CITY OF ALBUQUERQUE

Lot 3 Block 8 Volcano Cliffs Unit 22 SAD 228 6420 Canavio Rd. NW Grading and Drainage Plan Engineers Stamp Date: 5/12/2020 (D10D003E3) CO Certification Revised Date: 7/20/2021

Planning Department Development & Building Services Division DRAINAGE AND TRANSPORTATION INFORMATION SHEET (REV 11/2018)

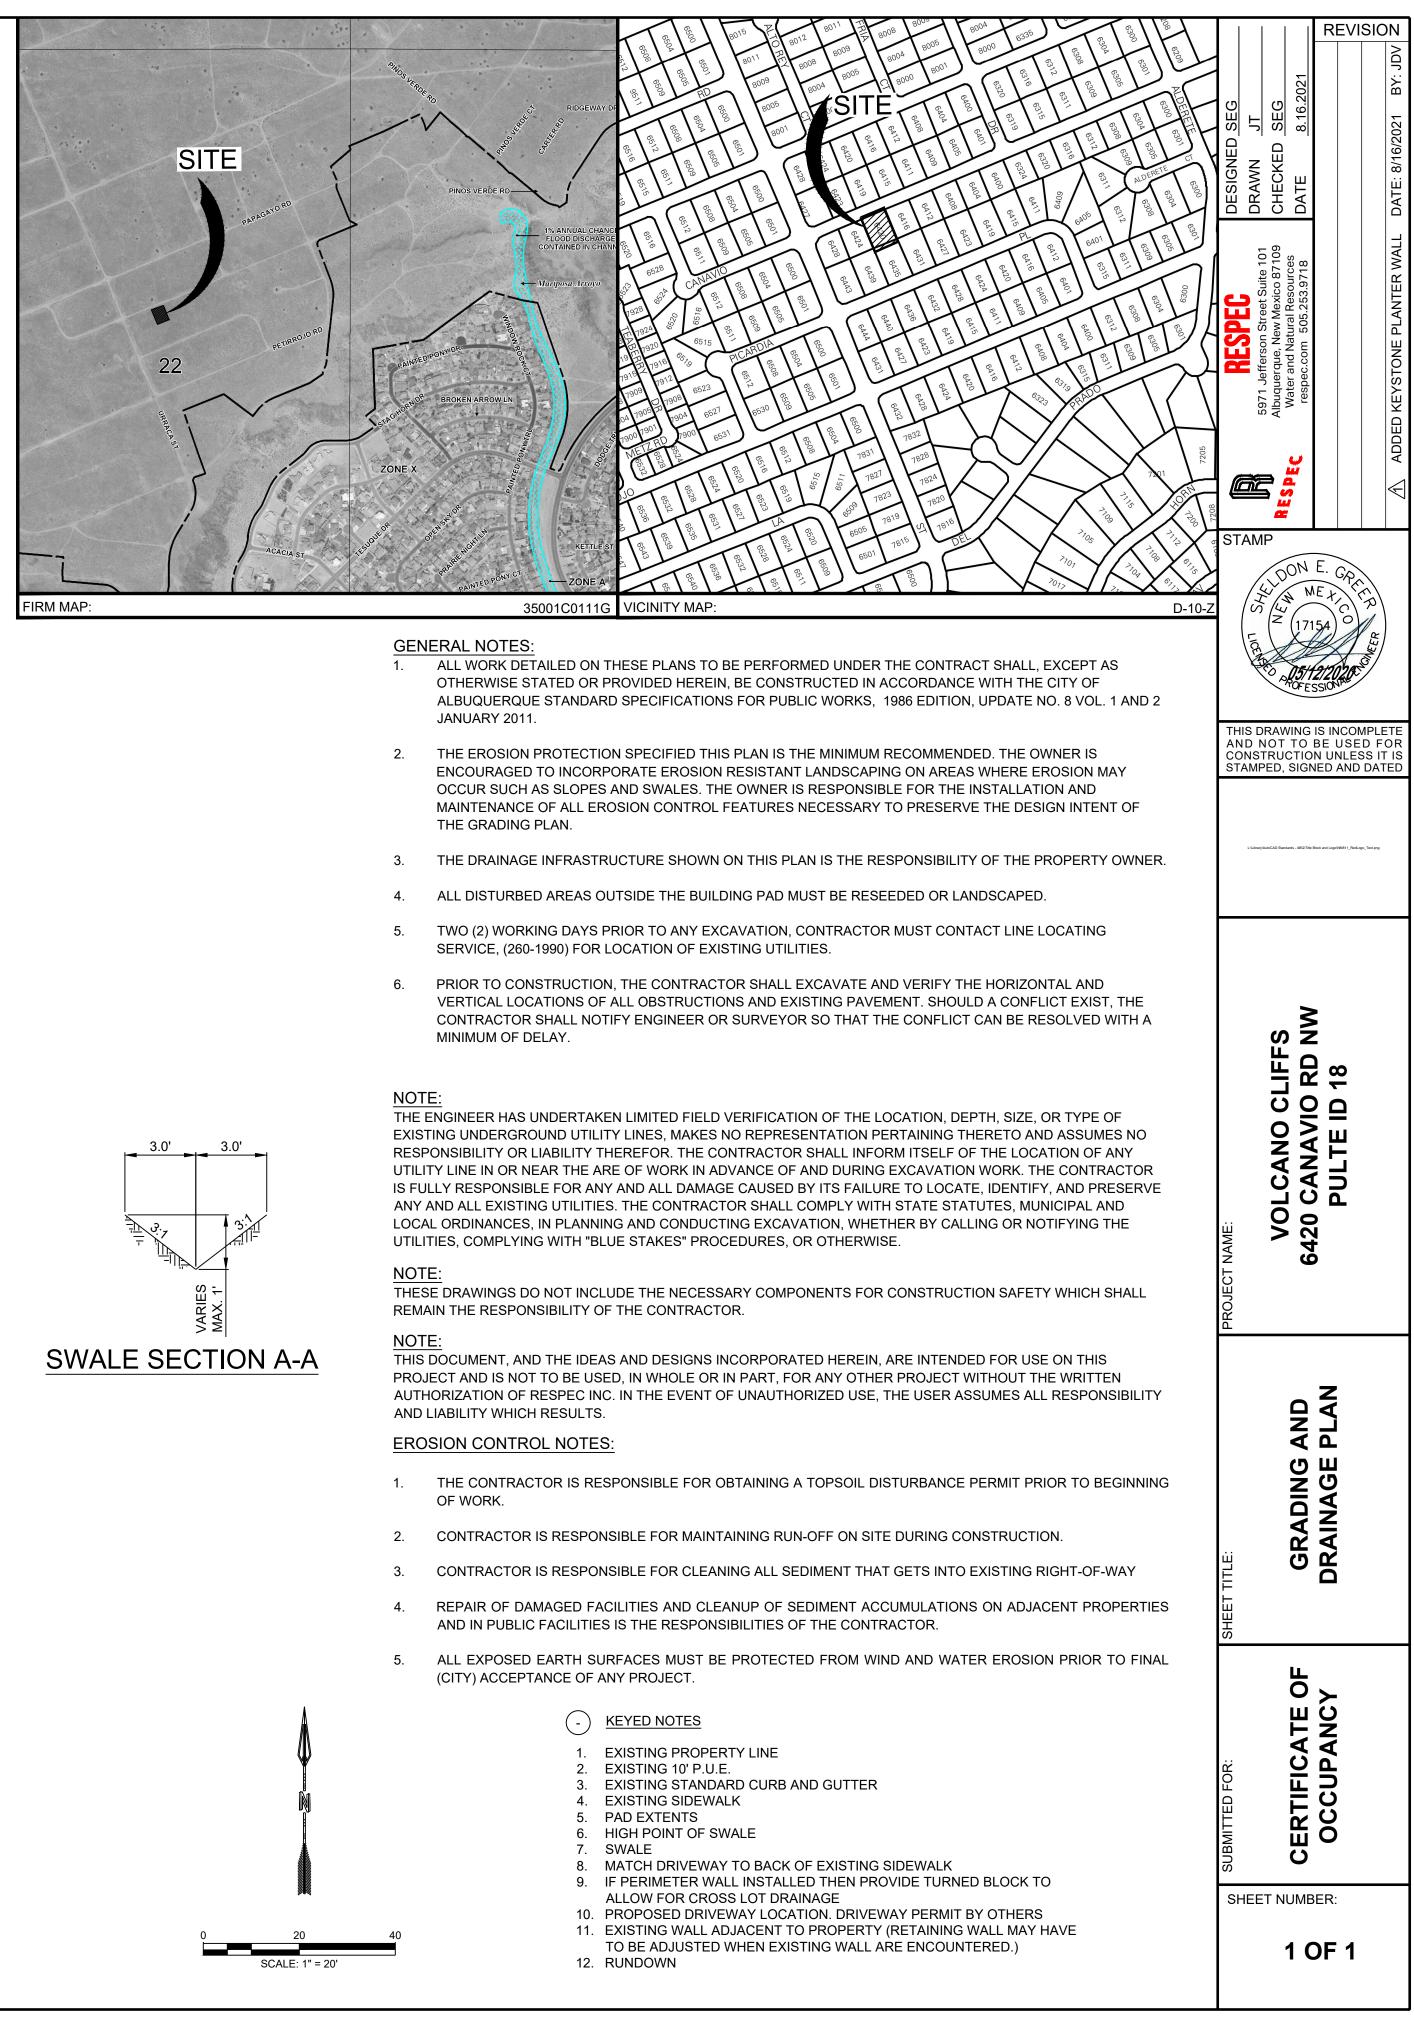
Based on the Certification received on 8/17/2021, the site is acceptable for release of Certificate of Occupancy by Hydrology.
